Subject: Remora (MacArthur) bus stop for comment

From: Chris Mancini <Chris.Mancini@brisbane.qld.gov.au>
Sent: Wednesday, 19 April 2017 12:37 PM
To: Corey Baldwin
Cc: Jaimee Boutcher-Hann
Subject: RE: Macarthur Ave Bus Stops

Subject: Northshore Hamilton - Remora MacArthur Upgrade signals drawings

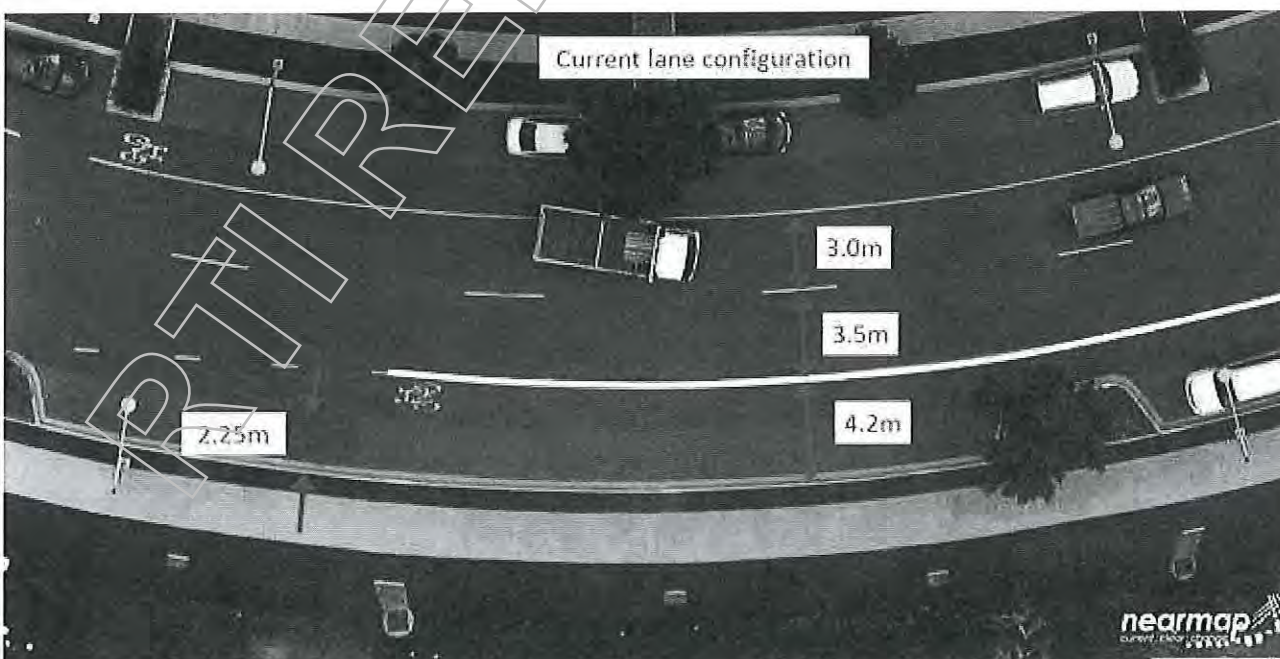
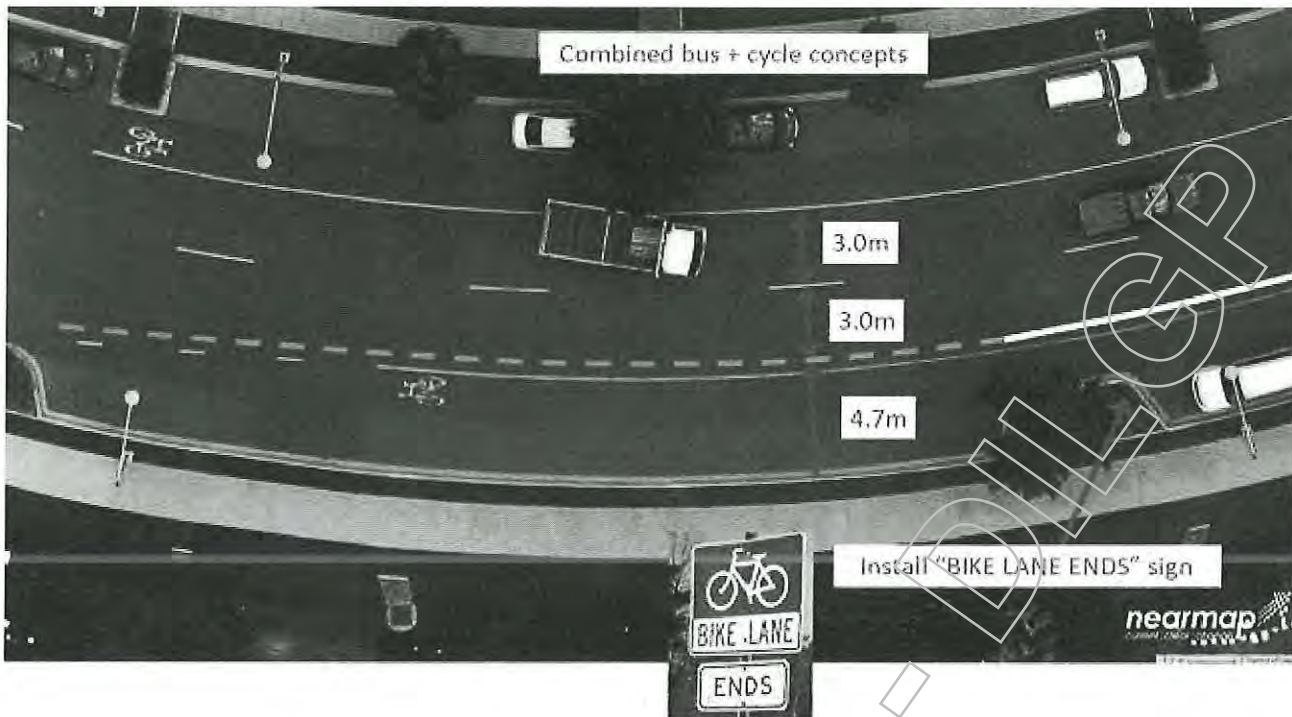
End the bicycle lane on the approach side to the bus stop using a "BIKE LANE ENDS" sign at the build out garden bed.

Reduce the adjacent traffic lane width from 3.5 to 3.0 metres, therefore move the edge-line/ continuity line 0.5 metres.

Make the bus stop a combined bus + bicycle facility approximately 4.7 metres wide with "broken yellow coloured pavement road marking". This will allow 2.85 metre (absolute) bus and mirror clearance (including 200 mm from front of kerb to edge of bus tyres) with 1.85 metre bicycle track.

I would not include pavement road marking for bus stop approach and egress tapers etc. Bus Operators will pull-in and pull-out at the bus stop in accordance with the position of the bus stop sign/J-pole (with bus stop timetables). I would also not include bicycle awareness zone pavement treatment (e.g. green coloured bicycle lanes normally used at conflict points where vehicles and cyclists cross paths etc.). That is I would use minimal pavement road marking with the interim design. Ultimate designs with high quality bus stops and conveyance vehicles would include different arrangements and configurations.

Reduce the regulatory speed limit from 60 km/h to 50 km/h at Macarthur Avenue because Northshore Hamilton includes parks, public spaces, and low to medium residential developments ("this is not an industrial area any more").

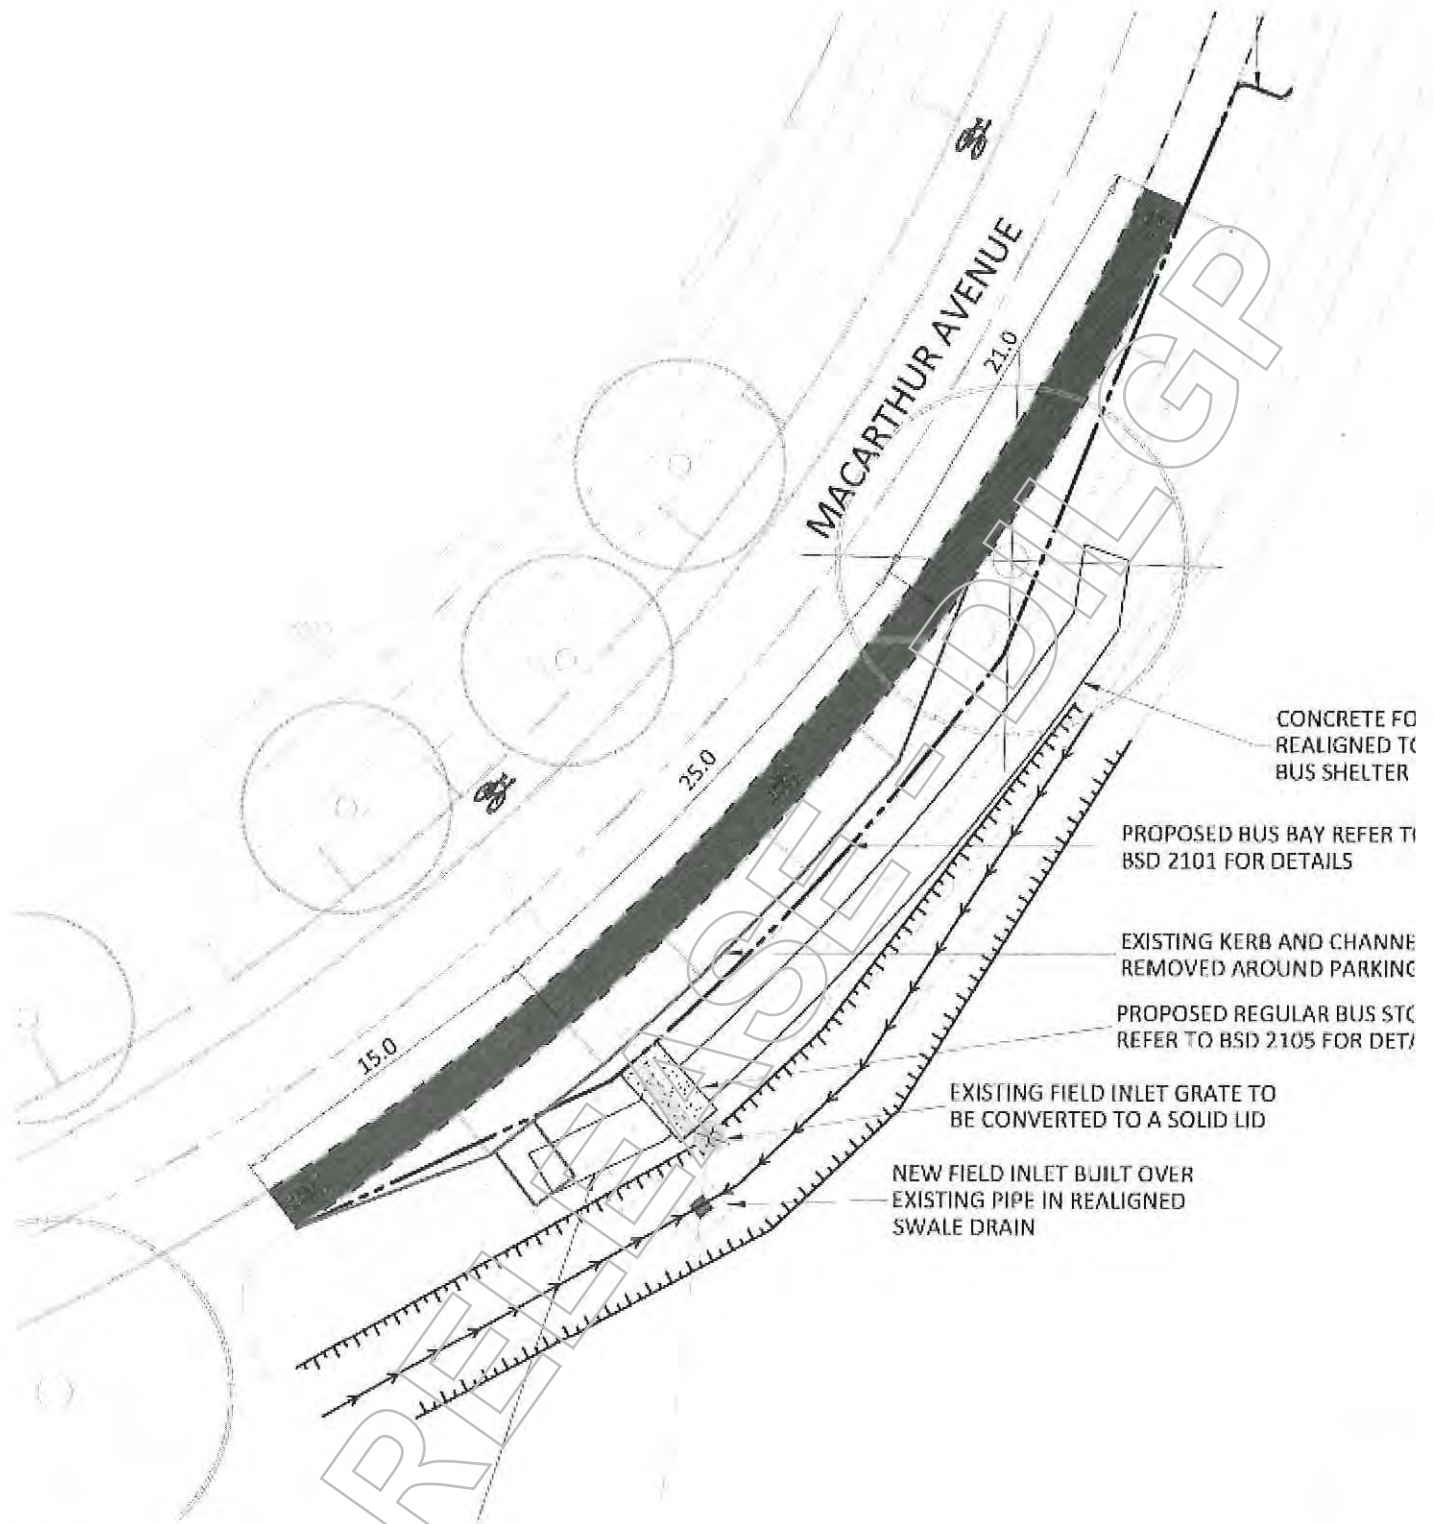
Could we look at ending the cycle track before the bus bay, as it effectively ends at the western most end of the carparks anyway?

I'd like to amend the interim stop at the café to reduce the work required. Below in pink shows my thoughts which BT and BCC didn't seem to have a problem with. I understand the width is not as per standard drawing and the taper lengths are also shorter than standard but We need to look at ways that don't require significant upgrades and impact on the figs.

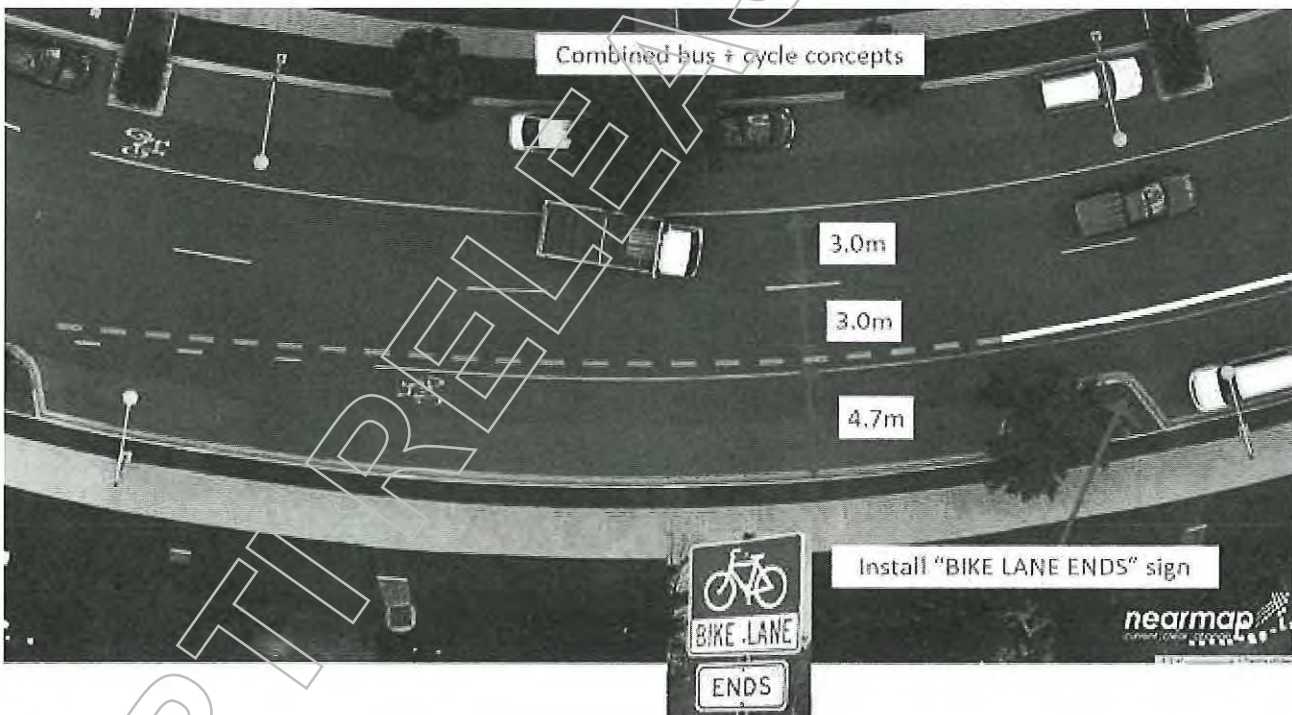
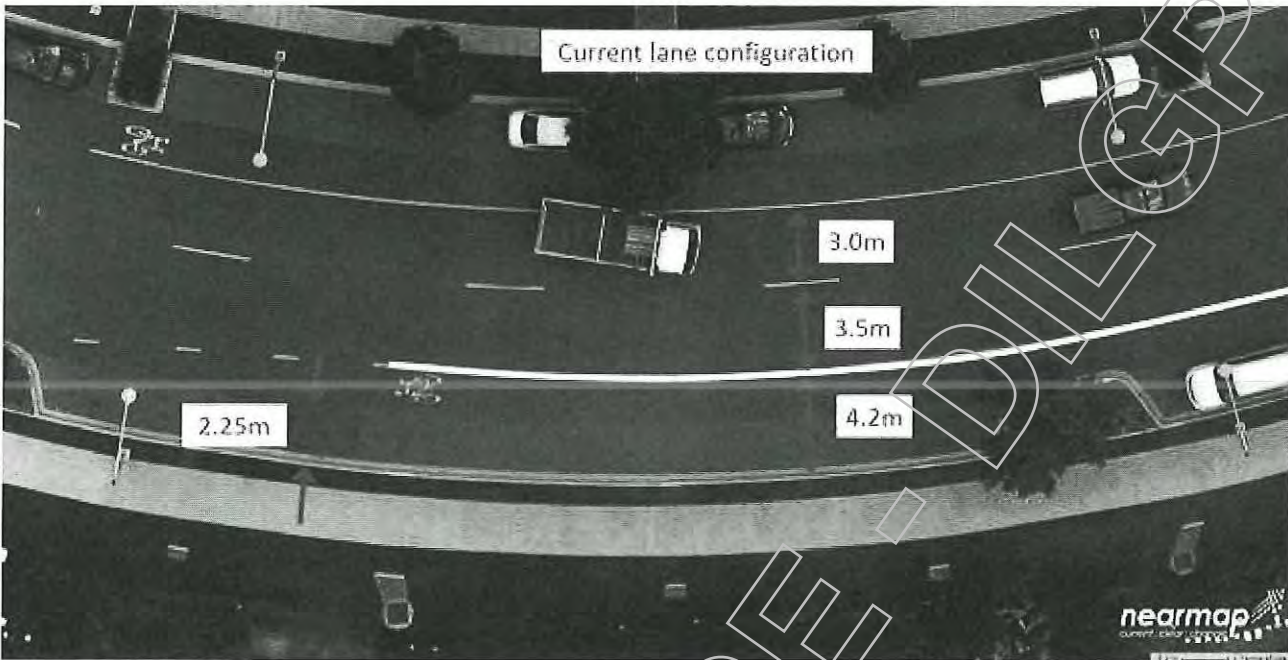
End the bicycle lane on the approach side to the bus stop using a "BIKE LANE ENDS" sign at the build out garden bed.

Reduce the adjacent traffic lane width from 3.5 to 3.0 metres, therefore move the edge-line/ continuity line 0.5 metres.

Make the bus stop a combined bus + bicycle facility approximately 4.7 metres wide with "broken yellow coloured pavement road marking". This will allow 2.85 metre (absolute) bus and mirror clearance (including 200 mm from front of kerb to edge of bus tyres) with 1.85 metre bicycle track.

I would not include pavement road marking for bus stop approach and egress tapers etc. Bus Operators will pull-in and pull-out at the bus stop in accordance with the position of the bus stop sign/J-pole (with bus stop timetables). I would also not include bicycle awareness zone pavement treatment (e.g. green coloured bicycle lanes normally used at conflict points where vehicles and cyclists cross paths etc.). That is I would use minimal pavement road marking

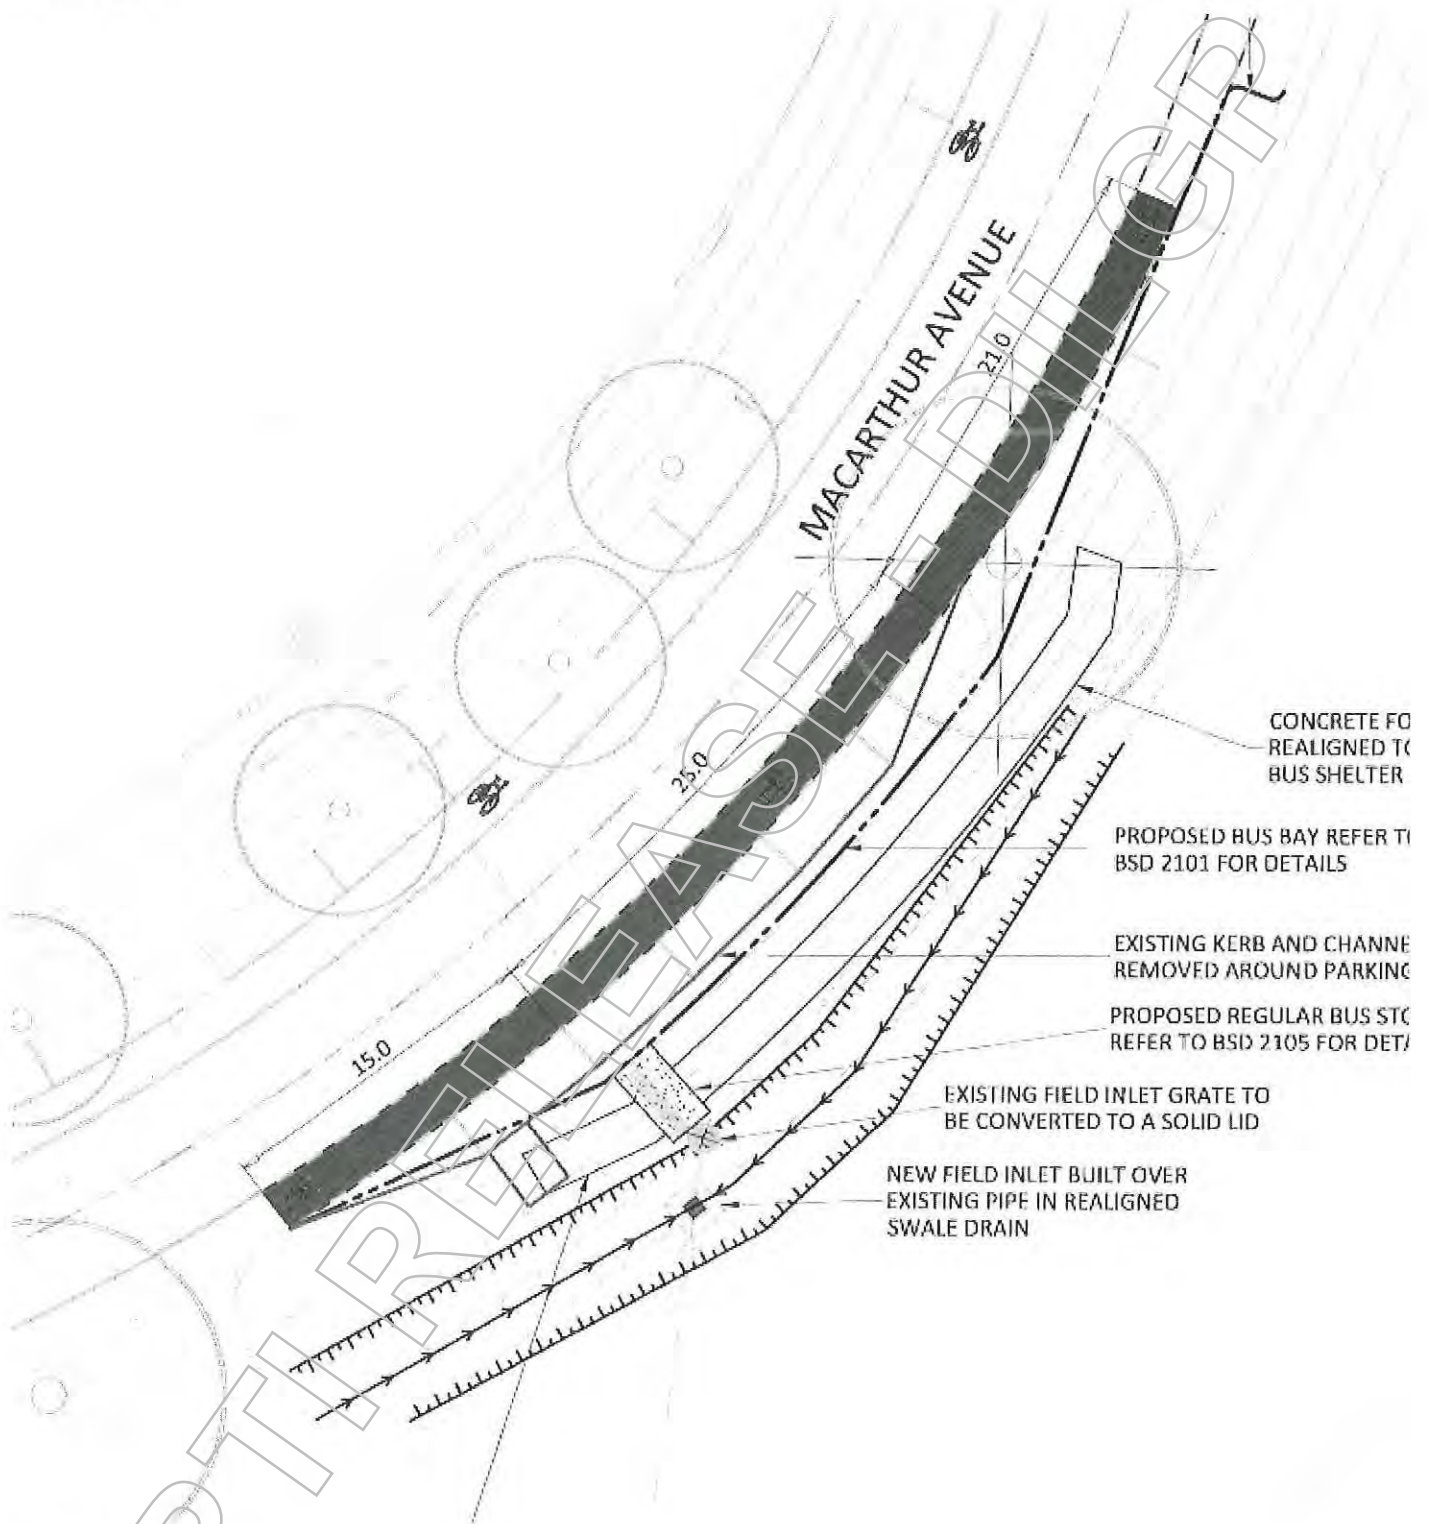
I'd like to amend the interim stop at the café to reduce the work required. Below in pink shows my thoughts which BT and BCC didn't seem to have a problem with. I understand the width is not as per standard drawing and the taper lengths are also shorter than standard but We need to look at ways that don't require significant upgrades and impact on the figs.
